MEMORANDUM

Subject: Supplemental Materials for the DHCD Workgroup Meeting - August 22, 2013

Code Change Form for the 2012 Code Change Cycle

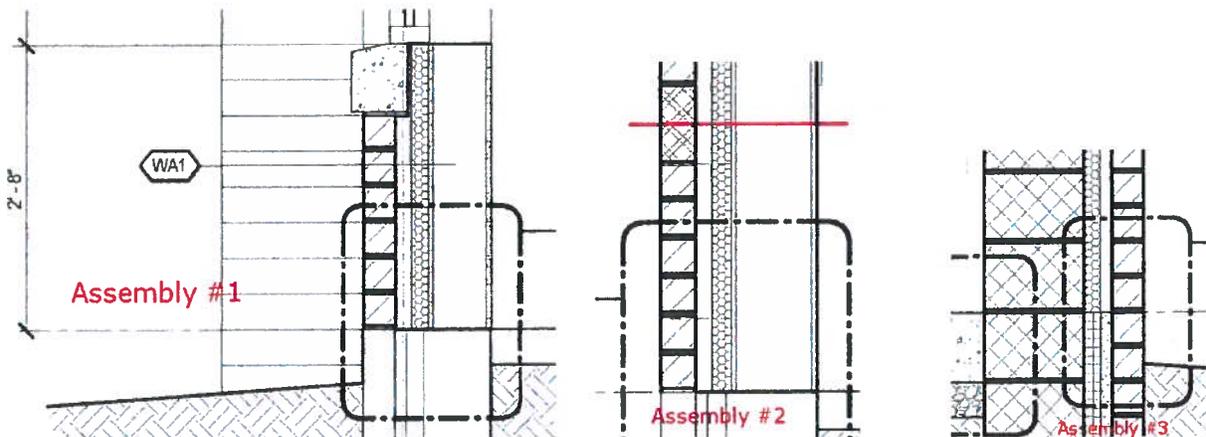
- The proposed code change includes text addressing the above. In other words, if a building has two assemblies, and the only difference is that one has CMU backup and the other has gypsum sheathing + steel studs + gypsum drywall backup (all are noncombustible materials), a second NFPA 285 test would not be required. Or, if the only difference was one assembly had facebrick and the other had split-face CMU as the veneer, a second NFPA 285 test would not be required.
- Refer to the examples below: Assembly #1 would require a test. The accent band of split-face CMU in Assembly #2 would require a second NFPA 285 test, and the change from steel studs/gypsum to CMU in Assembly #3 would require a third NFPA 285 test.

Figure 2. Post-test condition of an exterior wall assembly.

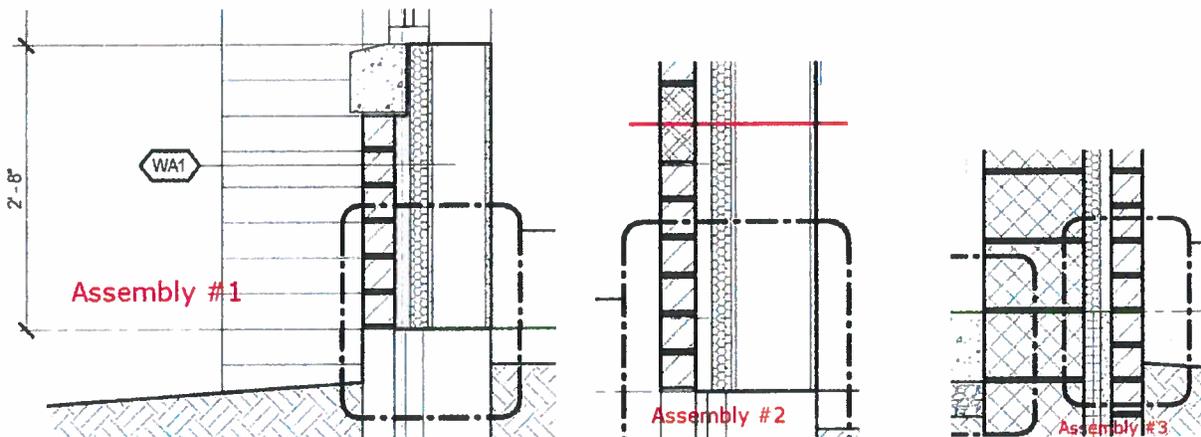
- The proposed code change includes text addressing the above. In other words, if a building has two assemblies, and the only difference is that one has CMU backup and the other has gypsum sheathing + steel studs + gypsum drywall backup (all are noncombustible materials), a second NFPA 285 test would not be required. Or, if the only difference was one assembly had facebrick and the other had split-face CMU as the veneer, a second NFPA 285 test would not be required.

- Refer to the examples below: Assembly #1 would require a test. The accent band of split-face CMU in Assembly #2 would require a second NFPA 285 test, and the change from steel studs/gypsum to CMU in Assembly #3 would require a third NFPA 285 test.
